CITY OF ALBUQUERQUE

Re: Seven Clover
3641 12th St NW
Site Plan
Architect's Stamp 8-27-23 (G14D062)

Based upon the information provided in your submittal received 12-4-23, the above referenced plan cannot be approved for Building Permit until the following comments are addressed:

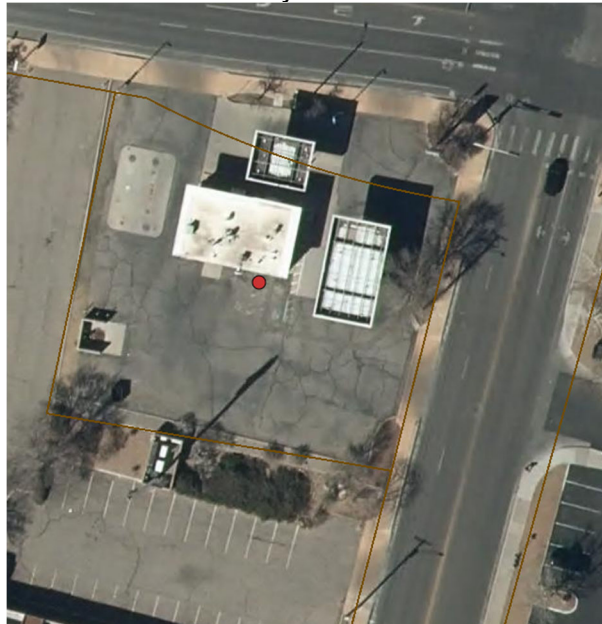
1. Complete the Traffic Scoping Form and send to Matt Grush.
TRAFFIC SCOPING FORM SUBMITTED
2. The BernCo Assessor database shows an interesting property line (Brown line) along the northern boundary. See below:

Please confirm this is the correct property line or provide information (e.g. plat) that shows a different property line.

Owner to submit more information
